MARKED UP PAGES

TENNESSEE VALLEY AUTHORITY BROWNS FERRY NUCLEAR PLANT (BFN) UNITS 1, 2, and 3

PROPOSED TECHNICAL SPECIFICATION (TS) CHANGE TS-352 REVISED PAGES

TABLE 3.2.8 INSTRUMENTATION THAT INITIATES OR CONTROLS THE CORE AND CONTAINMENT COOLING SYSTEMS

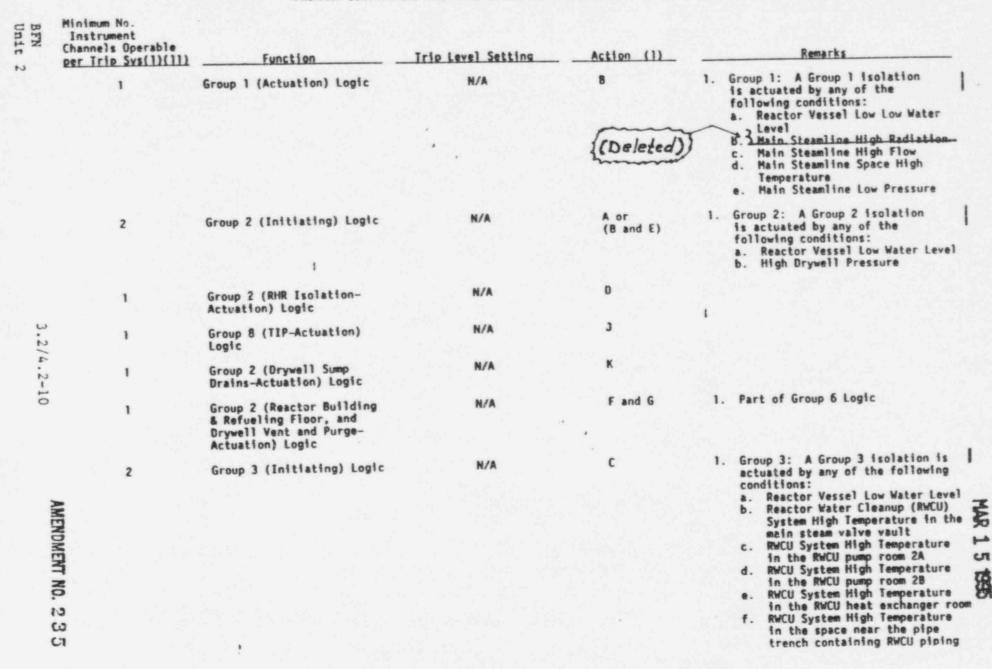
1(16)	Instrument Channel - Reactor Low Water Level Permissive (LIS-3-184, 185)	≥ 544" above vesseĭ zero.	A	 Below trip setting permissiv for initiating signals on AD
) DELETE	Instrument Channel - Reactor Low Water Level (LIS-3-52 and LIS-3-62A)	\geq 312 5/16" above vessel zero. (2/3 core height)	A	 Below trip setting prevents inadvertent operation of containment spray during accident condition.

modification requested by NRC Bulletin 93-03 is being performed, provided that the reactor Vessel water level instrumentation "anual and automatic initiating capability of CSS and LPCI will be available, but with a reduced number of instrument channels."
